NO. 85	DATE: 8/25/75
<u>ITEM(S) / PRODUCT(S):</u> SHUGART TECHNICAL MEMORANDA #16, 17 and 18

SHUGART ASSOCIATES
TECHNICAL MEMO

SUBJECT: NEW STYLE CARRIAGE ASSEMBLY

<p>IMMEDIATE SERVICE NOTICE</p>	NO. 153B	DATE: 10/16/78
	CATEGORY MASS STORAGE DEVICES #13B	
	SUBJECT CAUTION ABOUT ECN 7128 ON 7018 BOARDS CAUTION ABOUT ECN 7180 ON 6718 BOARDS

FIGURE 1

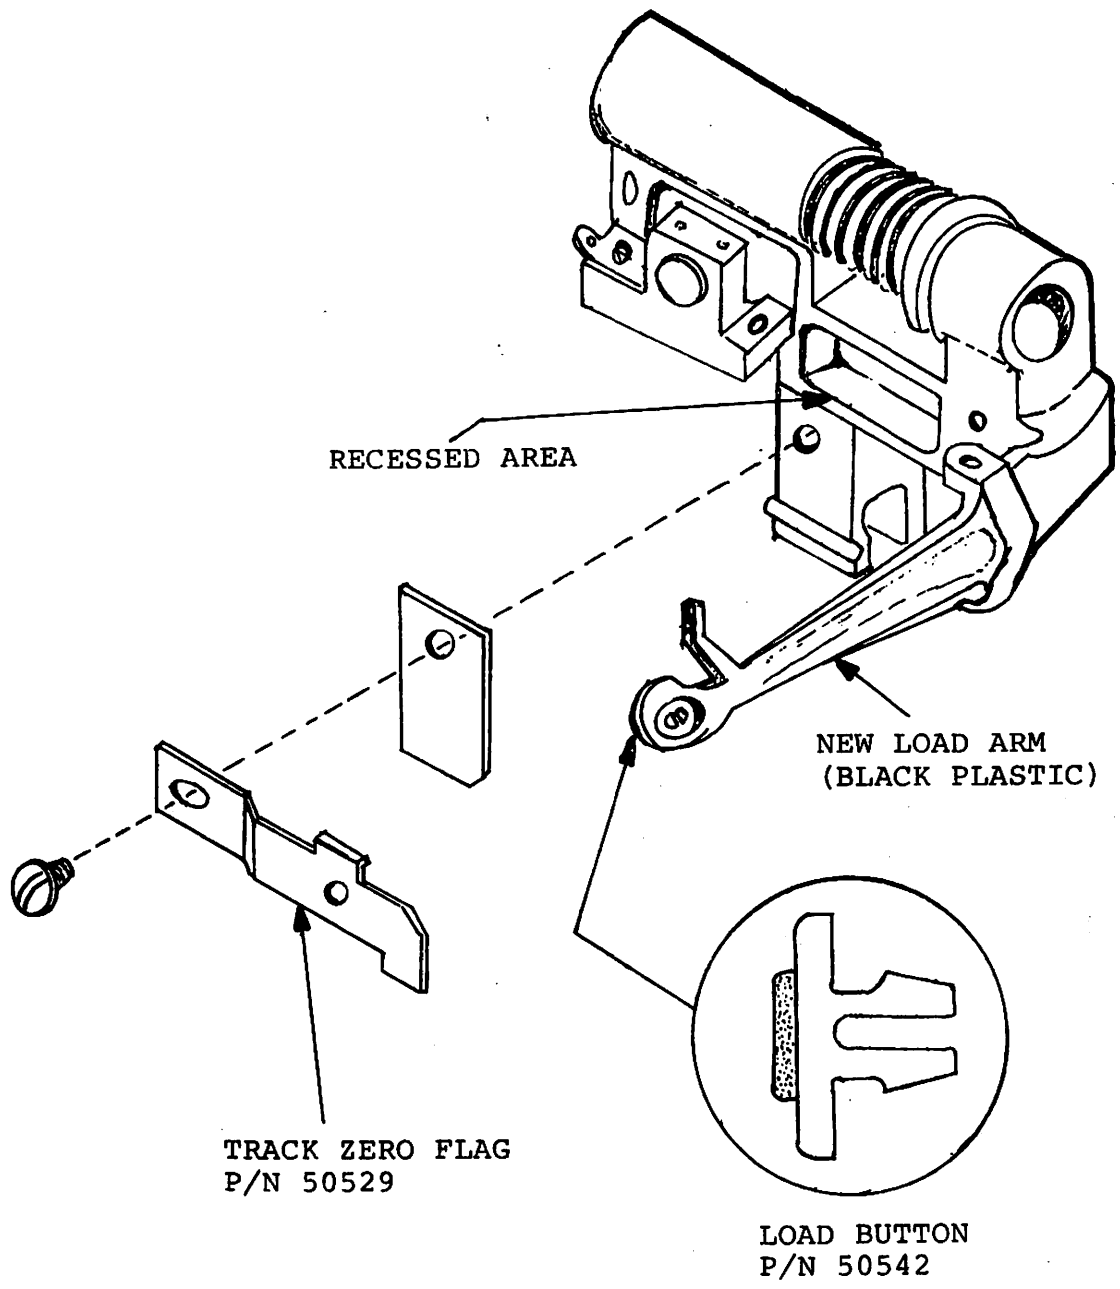
1. New type track zero flag to make adjustment easier. This flag is not compatible on early carriages. The carriage must have a recessed area as shown in Fig. 1 to be compatible.
2. New type load button. This button is a snap-in type for ease of replacement. This load button can ONLY be used on the black plastic load arm. See Fig. 1 for identification. On metal arms, continue using load button kit, P/N 50929.

3. New type load arm. The new load arm was implemented to incorporate the new snap-in load button and eliminate the two spring positions required if the drive was horizontally mounted with the PCB up. The new load arm is black plastic and is not field replaceable onto carriages with metal arms, see Fig. 1.

FIGURE 2

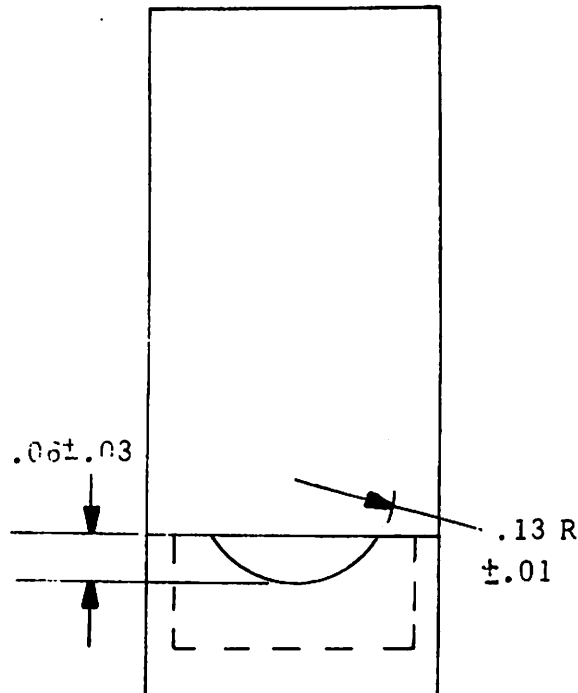
Load Bail Gauge, P/N 50391, has been reworked to allow for the new load arm. All gauges shipped after this date will be reworked. The gauges currently in the field should be reworked so they can be used on drives with the new load arm. Figure 2 illustrates the rework necessary. Reworked tools are usable on old style carriages.

- PURPOSE:** Provide clearance so Load Bail Gauge can be used with plastic load arm.
- FIELD REWORK:** Using an Exacto Knife or equivalent, carve the end of the tool approximately as shown.
- FACTORY REWORK:** Machine notch in part as shown.

FIGURE 1

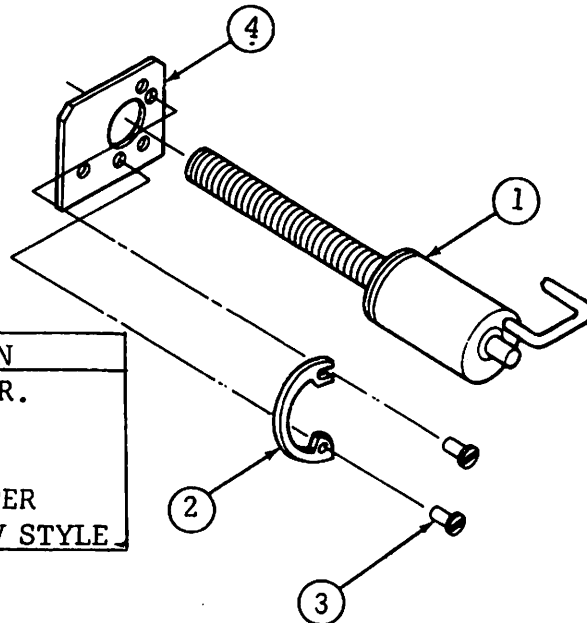
Shugart floppy disk drives above S/N 17762 shipped after 7/20/75 have a new style stepper motor mounting clamp. With this new mounting clamp, head removal and radial adjustments will be easier to make. The three cleats have been eliminated and replaced with a clamp (refer to Fig. 1). This clamp cannot be installed on drives where the stepper is held with the three cleats unless the stepper plate is replaced. This is NOT RECOMMENDED.

To remove stepper, loosen the two clamp screws and pivot the clamp off of the ridge in the stepper. To make adjustments it is only necessary to loosen the two screws slightly and turn the stepper. The rest of the adjustment is identical.

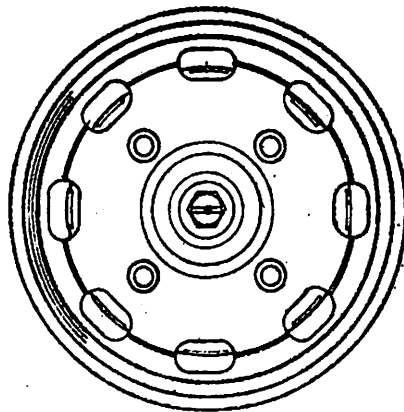
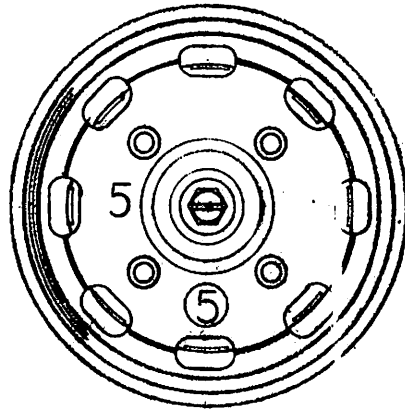
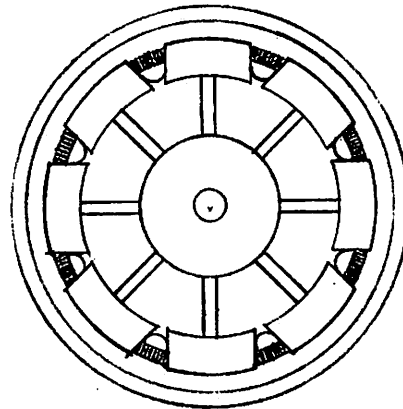
Four versions of this assembly (item 13, page 6, S.B. #46.2) have been produced; only the last (most recent) version is not prone to breakage of the finger ring (item 16, page 96, S.B. #46.2) and/or center post (items 17/18/19, page 98, S.B. #46.2).

FIRST VERSION - Disk drive units up to Shugart serial number 33600. Hub Clamp assembly has small rivets on the Hub Clamp. The Finger Ring is fragile.

SECOND VERSION - Disk drive units with Shugart serial numbers from 33601 to 40000. Hub Clamp assembly has larger rivets on the Hub Clamp. The finger-ring is stronger, but still likely to break.

THIRD & FOURTH VERSIONS - Disk drive units with Shugart serial numbers from 40001 and up. Hub Clamp assembly has no rivets. The Finger-ring is made of a strong, light color plastic substance similar to Teflon^R. The *third* version has a fragile center post made from a glasslike material; the *fourth* version has the same style center post, but it is made from a stronger plastic material. The part number for this latest, durable Hub Assembly is Shugart #50254-2; WL #726-1021.

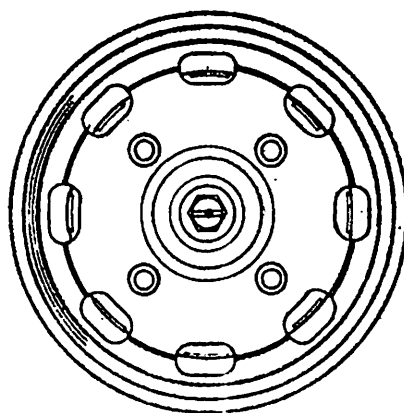
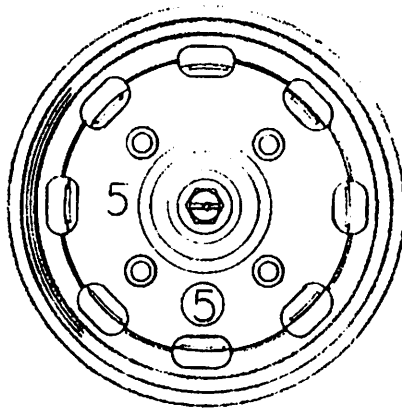
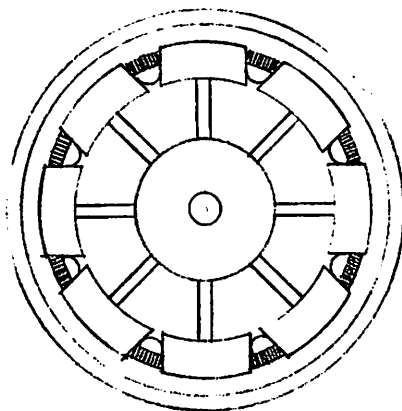
Four versions of this assembly (item 13, page 6, S.B. #46.2) have been produced; only the last (most recent) version is not prone to breakage of the finger ring (item 16, page 96, S.B. #46.2) and/or center post (items 17/18/19, page 98, S.B. #46.2).

FIRST VERSION - Disk drive units up to Shugart serial number 33600. Hub Clamp assembly has small rivets on the Hub Clamp. The Finger Ring is fragile.

SECOND VERSION - Disk drive units with Shugart serial numbers from 33601 to 40000. Hub Clamp assembly has larger rivets on the Hub Clamp. The finger-ring is stronger, but still likely to break.

THIRD & FOURTH VERSIONS - Disk drive units with Shugart serial numbers from 40001 and up. Hub Clamp assembly has no rivets. The Finger-ring is made of a strong, light color plastic substance similar to Teflon^R. The *third* version has a fragile center post made from a glasslike material; the *fourth* version has the same style center post, but it is made from a stronger plastic material. The part number for this latest, durable Hub Assembly is Shugart #50254-2; WL #726-1021.

If only the latest style center post is needed, order WL #726-1065 (Shugart #50684). The center post is easily removed from the backside of the Hub Clamp assembly, using needle-nose pliers.

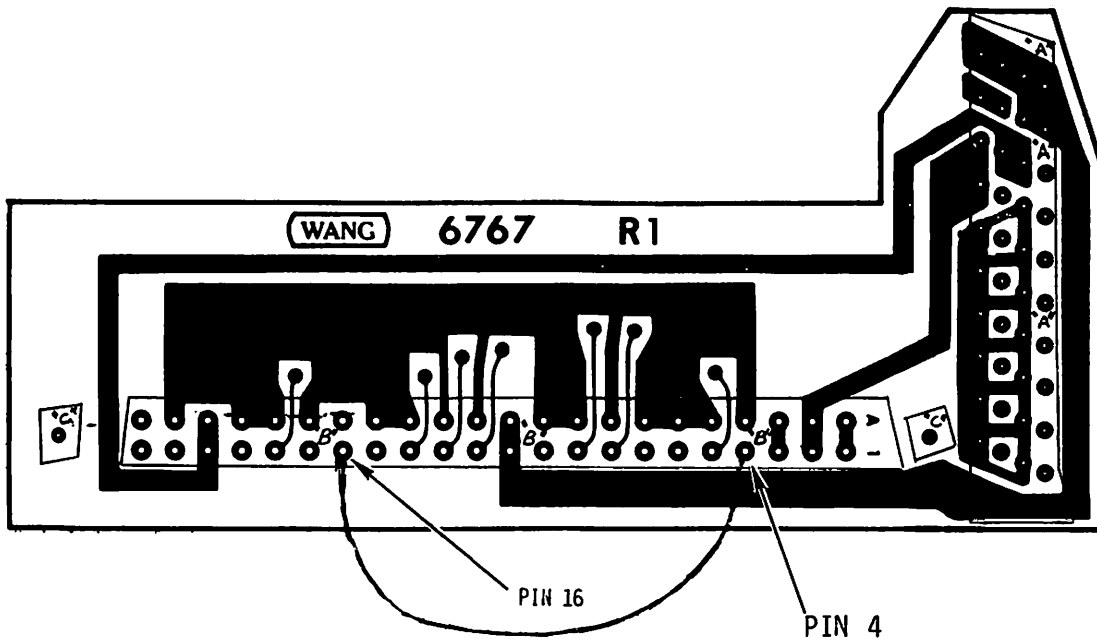
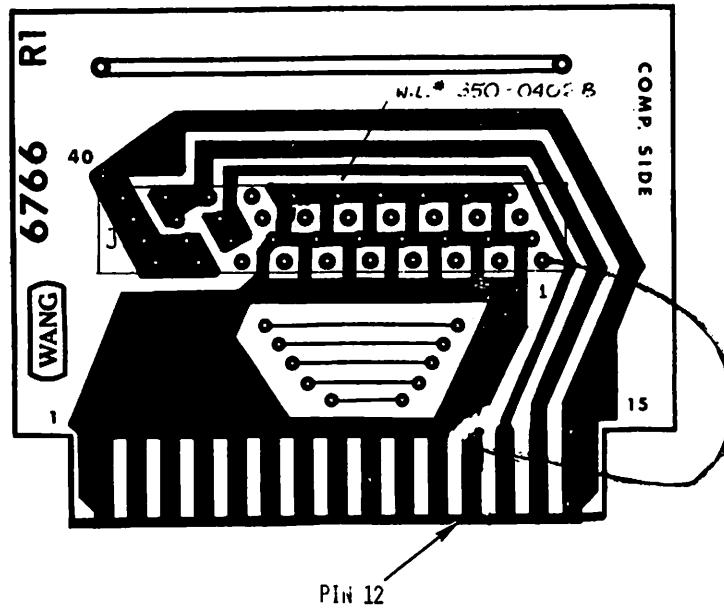
- 1) Isolate pin 12 on the 6766 R1 connector by cutting the etch as shown in the figure.
- 2) Connect a small piece of wire from pin #1 of the 40 pin connector on solder side to pin 12 on the 6766 board.
- 3) Connect a small piece of jumper wire from pin 4 to pin 16 on solder side, on PC board 6767 R1.

Steps 1 through 3 upgrade the 220-3011 cable. The cable is now compatible for all 2270 series diskette drives.

FIGURE 1

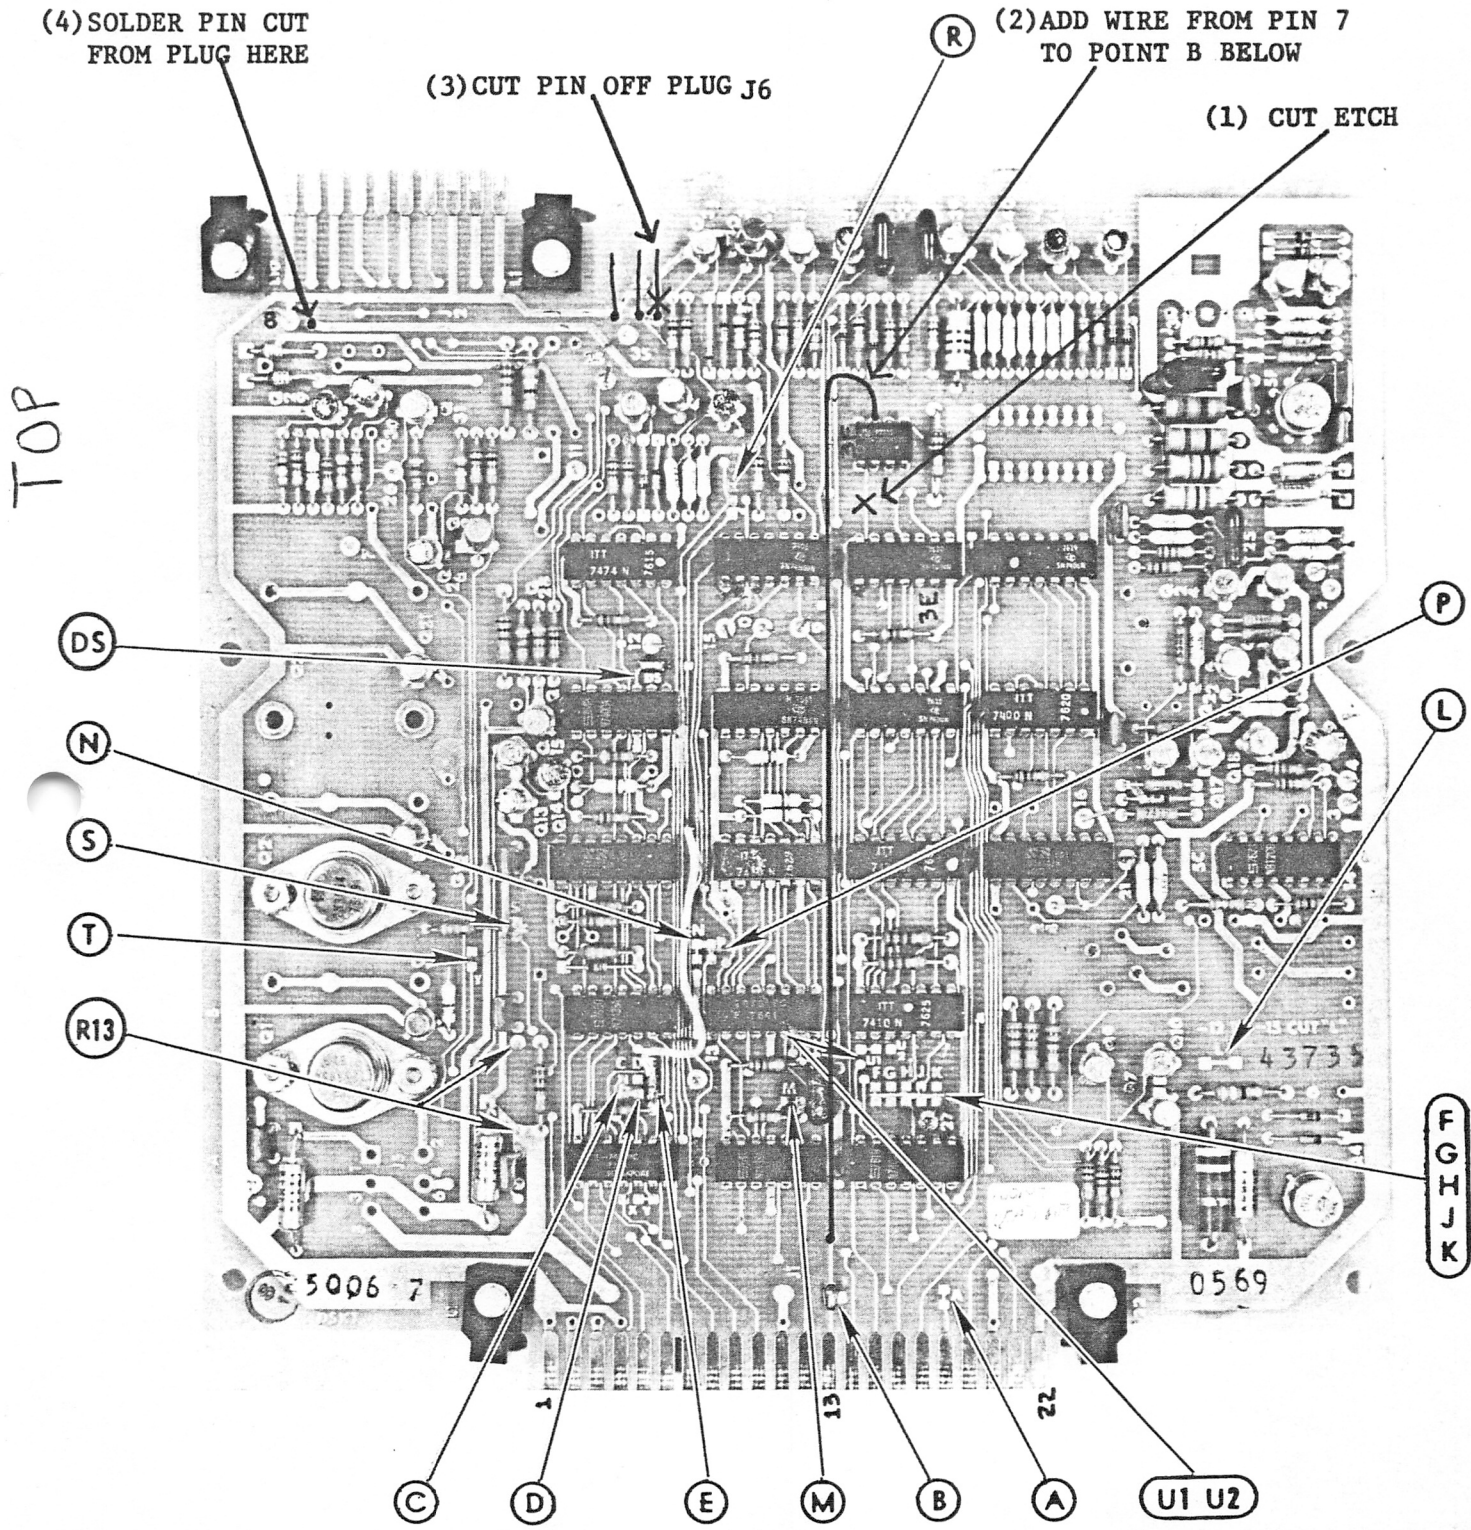
When replacing the floppy drive in a system with one that does not have the locking door latch and active light, swap the face plate and locking door latch with the new drive and modify the drive according to the instructions below.

1. Remove old face plate and door latch
2. Install new face plate with locking door latch and active light
3. Cut etch going between pins 1 and 2 of 8 pin IC 3F as per figure #1 (This etch runs from IC 3E Pin 2 to IC 3F Pin 7)
4. Add a jumper wire between pin 7 of IC 3F and the plate thru above point (B), which is tied to pin 13 component side of the I/O connector.
5. Cut bottom or top pin off of plug J6 and save pin for next step
6. Solder pin cut from plug into plate thru next to TP(8)
7. Connect 3 pin plug coming from the locking mechanism PCB located on the back of the door latch to J6
8. Connect the single wire coming from the locking mechanism PCB to the pin that you soldered next to TP 8
